118 Congress Street

Bike Racks

Parking Garage – Grit Separator

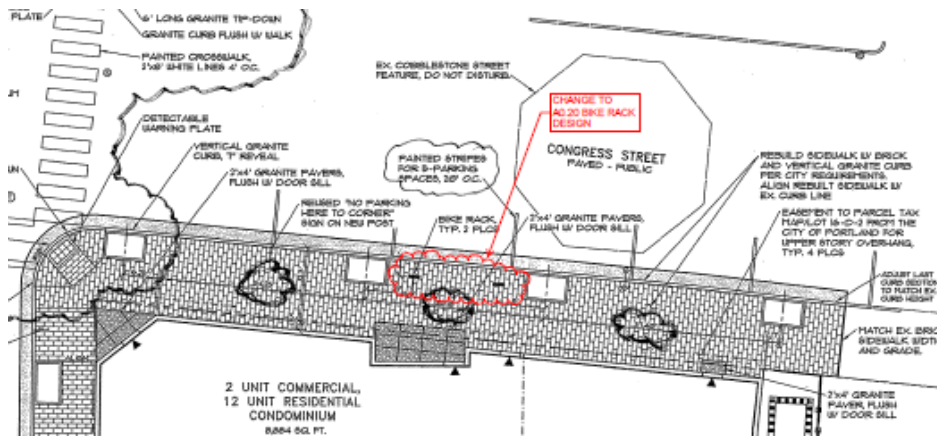
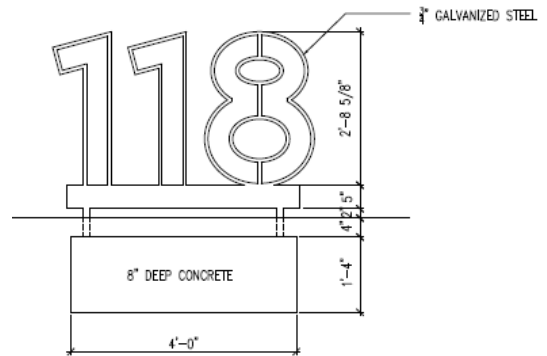
1. **Proposed Amendment to an Approved Plan:** On Wednesday, March, 18th, David Lloyd, representing Chip Newell, applicant, requested an amendment to the approved site plan to install a custom made bike rack in the public right-of-way parallel to the curb line. As part of the submission, Chip Newell has offered to have the condominium maintain and replace the bike rack (e-mail attached).

2. **Approved Plan: and Technical Manual Standards:** The custom rack was submitted in the original submission, but the final approved plans show two Dero bike racks meeting the City's standards located in the public sidewalk (shown above). Since the plan showed the required type of bike racks in the public right-of-way, this was not raised as an issue. An excerpt from the Transportation Section of the Technical Manual is as follows:

At the DPS meeting and the Development Review meeting, Tom Errico questioned the functionality of this bike rack. The longterm maintenance was also raised along with support for a unified municipal streetscape for such features, so it is clear the rack is for public use. Also, as designed it is hard to distinguish this as a bike rack versus signage for the building.

6. **Staff Recommendation:** The staff continues to recommend that the custom made bike rack be located on the private property and to retain the two Dero bike racks in the public right-of-way.

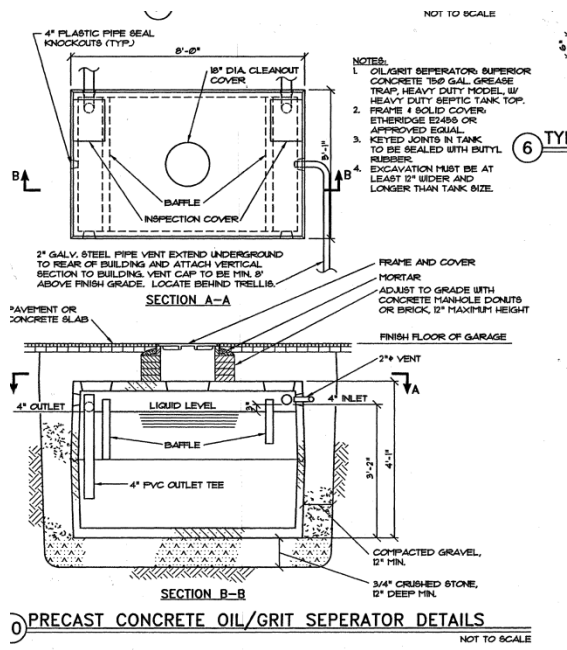
While the design of the proposed bike rack was attractive and related to the Hotel, the City needs to consider the desired continuity of neighborhood streetscape features. Consistent treatment of sidewalks, tree wells, and other features are intended to knit individual buildings into the larger public streetscape. In addition, the City becomes responsible for the maintenance and replacement of public infrastructure located within the street right-of-way. Thus Portland's Technical Manual specifies the

requirements for infrastructure to be installed in the city right-of-way, including the standards for the bike racks. <http://me-portland.civicplus.com/DocumentCenter/Home/View/2353> Refer to pages 65 and 66 in the Transportation section for bike racks.

The technical manual has specifications for street lights that are chosen to reflect the character of specific neighborhoods. The city is open to considering alternative bike racks that meet functional requirements, quality of materials/finish, cost effective to maintain, and relate to the neighborhood context. This would require amendments to the Technical Manual that must be adopted by the Planning Board. Bruce Hyman, Transportation Program Manager, is aware of your interest and others to consider alternatives. Currently, the position for the bike and pedestrian coordinator is vacant, but it is something that could be considered at a later time.

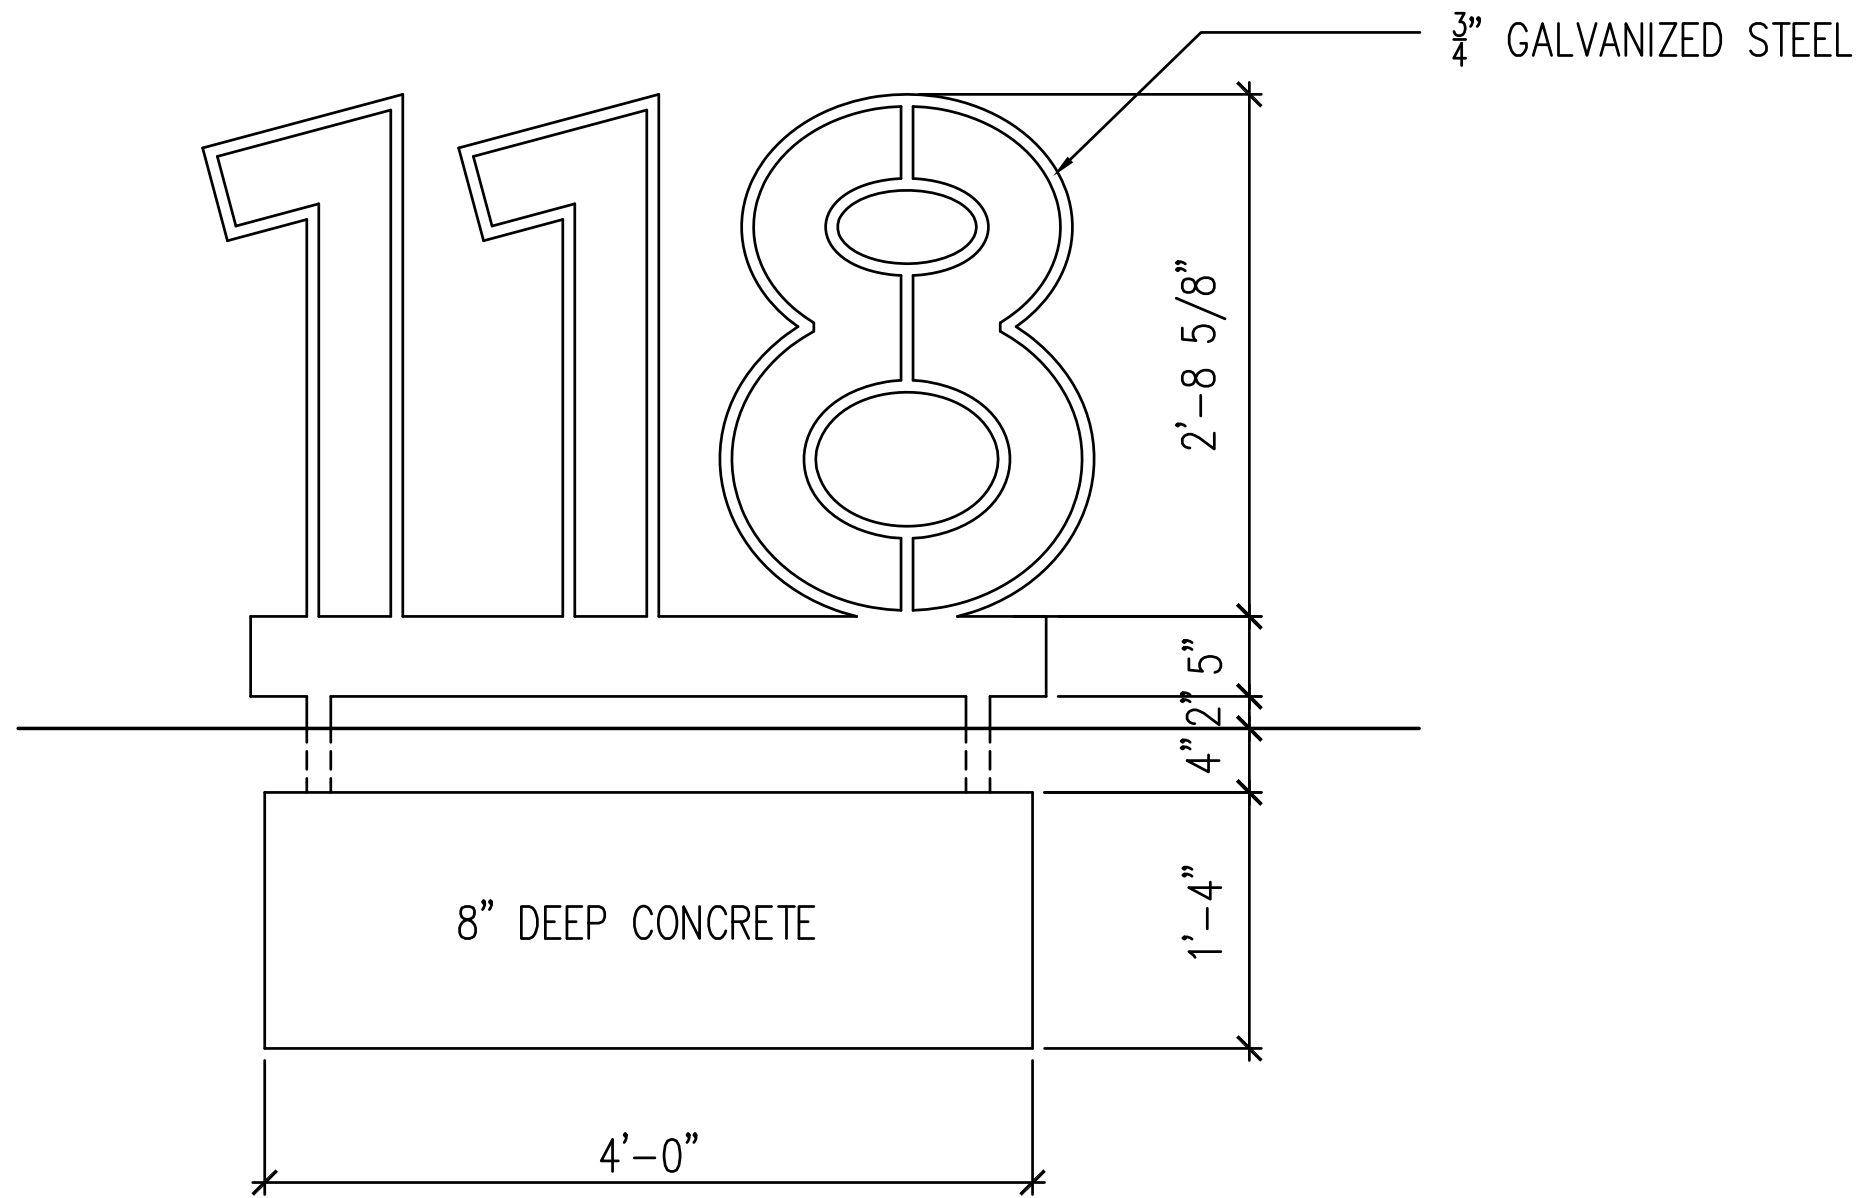
1. The plans for 118 Congress Street included a oil/grit separator in the structured parking area. The construction detail is inserted and it was shown in the floor of the garage on the site plan.

2. While the applicant argues that this is not required in the Maine, the following are the comments from David Senus:

During review of covered parking structures, the City of Portland Department of Public Services has consistently required Applicants to provide a structure designed to remove oil and grit from the floor drain system prior to connection into the City's Combined or

Sanitary Sewer System. This is typically a stand-alone structure designed with a sump and a down-turned outlet with oil/floatable storage capacity in the configuration shown on the 118 Munjoy Hill Plans (sheets C1.4 & C1.7), dated 3/27/2014. Although there is no specific code reference that I can point to for this requirement for parking garage areas, the City never allows runoff from a paved/traveled area to enter their system without some means of grit/sediment removal. Specifically the City of Portland Technical Manual requires 3' deep sumps on all catch basin structures, along with a Casco Trap or Snout on the outlet:

- 3. Staff Recommendation:** The staff offered the option of the catch basin described by David above that could be installed inside the garage or outside. If it is outside in the driveway apron (within the street right-of-way), then a license or agreement that the condominium association would be responsible for all maintenance and replacement would be required. The applicant's engineer has indicated that there is insufficient space in the driveway apron due to underground utilities. While the floor drains do have baskets for collection of debris, the units do not handle oil and need frequent cleaning. DPS felt those units were not adequate. DPS is requesting an alternative that more effectively addresses grit, oil and floatables.

- *City of Portland Technical Manual 2.7.6. All catch basins shall be constructed with a minimum sump of 3'.*
- *City of Portland Technical Manual Figure II-2 and II-9 reference and show Casco Traps for catch basin outlets*

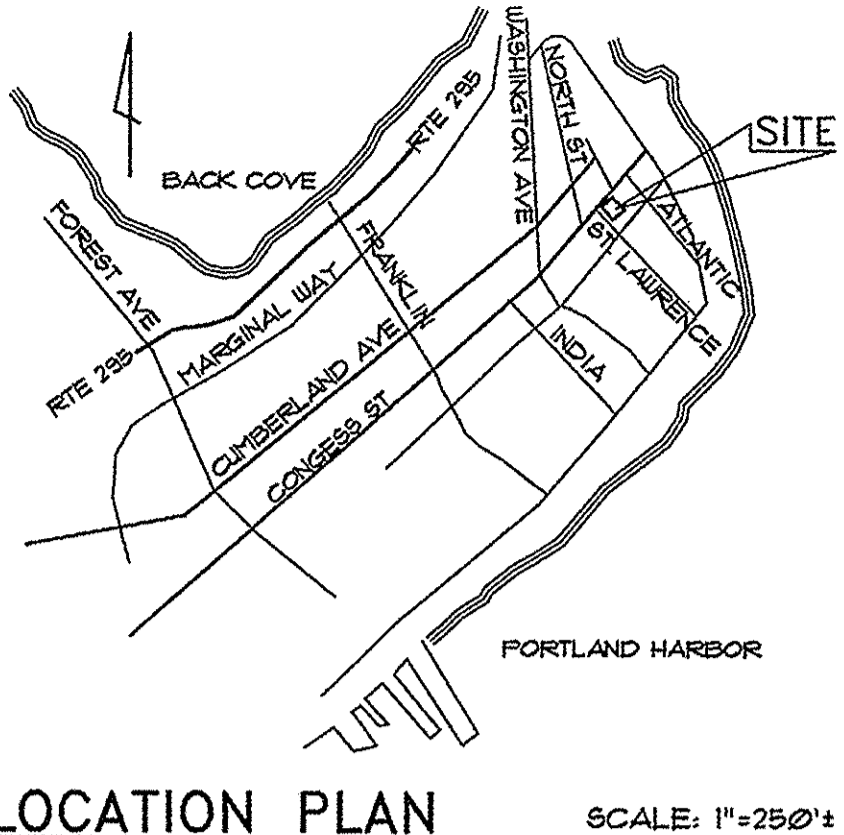
In summary, in a typical parking garage scenario, floor drains can be designed to flow through an oil and grit separator or can be collected in City of Portland Standard catch basins with 3' deep sumps and a trap on the outlet. My understanding is that neither of these items have been installed at the 118 Munjoy garage.

Covered garage spaces receive a significant amount of sediment, grit and oil drippings from vehicles, arguably just as much as uncovered parking spaces. The runoff from covered garage spaces tends to be very dirty, as it concentrates and is typically flushed out when the garage area is washed out.
